Notice of Intent

Type of Action: APD Change

XTO respectfully requests approval to make the below listed changes to the approved APDs.

WELL NAME	API Number	Pad
JRU Apache U Federal Com 706H	30-015-56296	A
JRU Apache Federal Com 710H	30-015-56298	C
JRU Apache Federal Com 711H	30-015-56299	C

Previous Design: 4-String Design – Engineered Weak Point**[Figure F] 4 String – 2nd Intermediate casing engineered weak point**

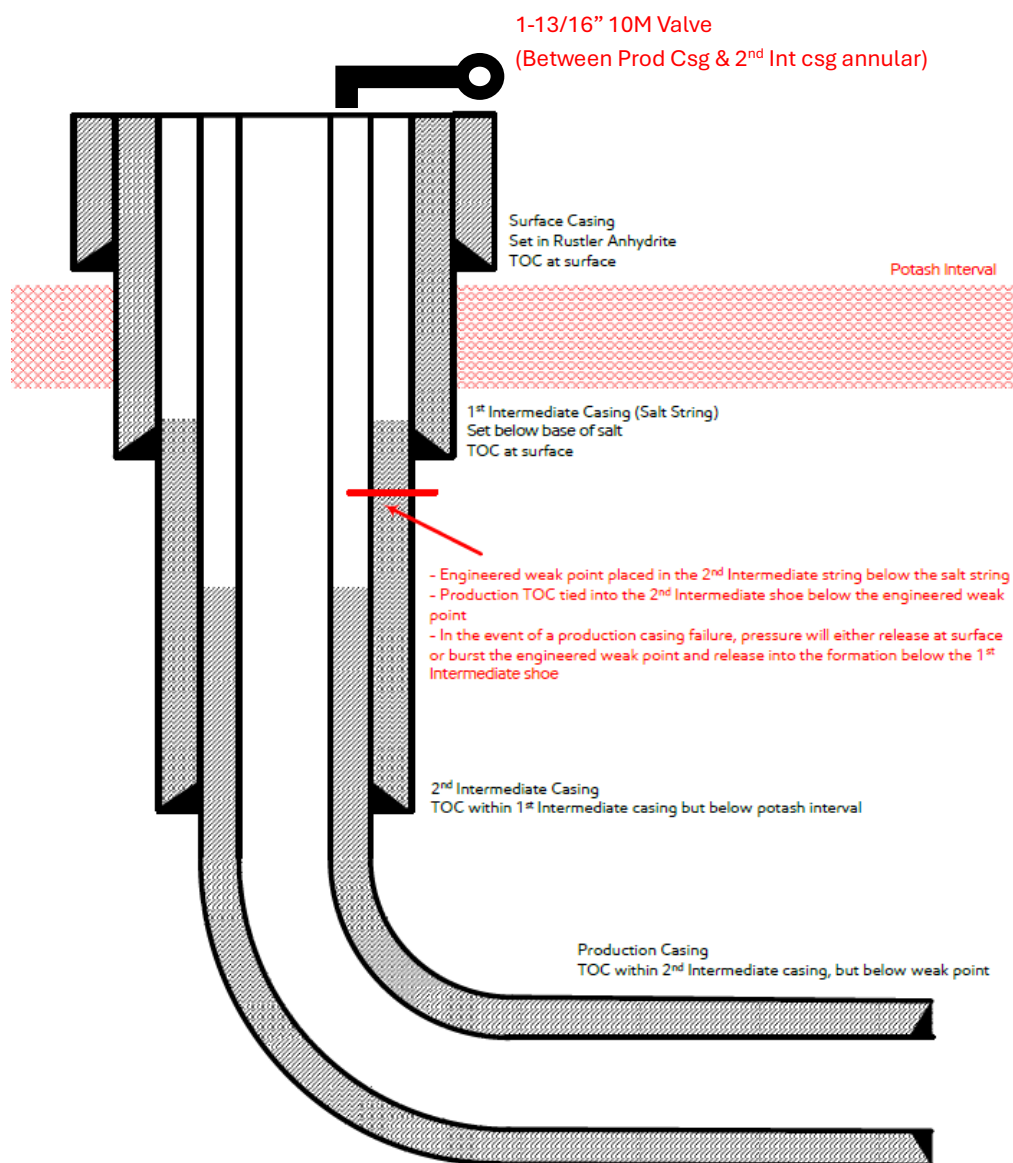
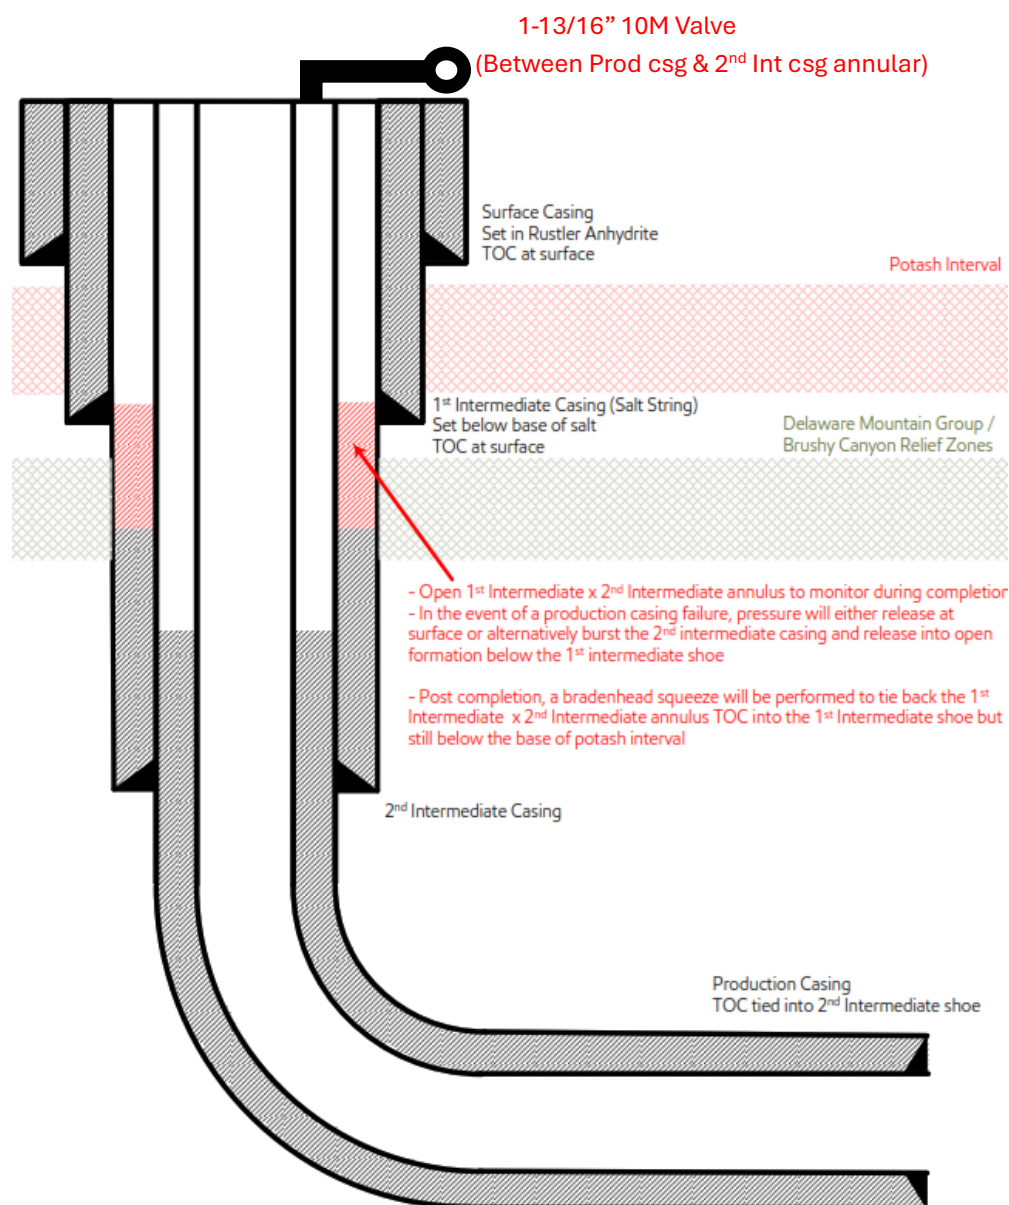
1. Casing design to be changed from the "4-String Design – Engineered Weak Point" (FIGURE F) to the "4-String Design – Open 1st INT x 2nd INT Annulus" (FIGURE D). An open annulus will be utilized and monitored during completions operations.

Post completion, bradenhead squeeze will be performed to tie back the 1st intermediate x 2nd intermediate annulus. TOC will be placed into the 1st intermediate shoe but still below the base of Potash interval.

- 1) Alignment with KPLA requirements per schematic per schematic below, with engineering weak point casing design and utilizing new casing that meets API standards.
- 2) Contingency plans in place to divert fluids away from salt interval in event of production casing failure.
- 3) Intermediate 2 casing will consist of a primary cement job with TOC at the top of the Brushy Canyon formation within the Delaware Mountain Group.
 - a. Bradenhead squeeze to be completed after primary cement job to tie back TOC to intermediate 1 "Salt string" & below Marker Bed 126 "Potash Interval".
- 4) Production cement to be tied back no less than 500' inside previous casing shoe (intermediate 2 casing) and below the engineered weak point.

- 1) Alignment with KPLA requirements per schematic above, leaving open annulus open for pressure monitoring during frac and utilizing new casing that meets API standards.
- 2) Contingency plans in place to divert fluids away from salt interval in event of production casing failure.
- 3) **Intermediate 2 primary cement** job with TOC within Delaware Mountain Group with 0% excess & below the minimum 500' from intermediate 1 casing shoe
 - o **Intermediate 2 bradenhead squeeze** to be completed within 180 days after completions to tieback TOC to salt string at least 500ft but with top below Marker Bed 126.
- 4) Production cement to be tied back no less than 500ft inside previous casing shoe.

New Proposed Design: 4 – String Design – Open 1st Int X 2nd Int Annulus (ICP 2 below relief zone)

[Figure D] 4 String – Uncemented annulus between 1st and 2nd intermediate casing strings
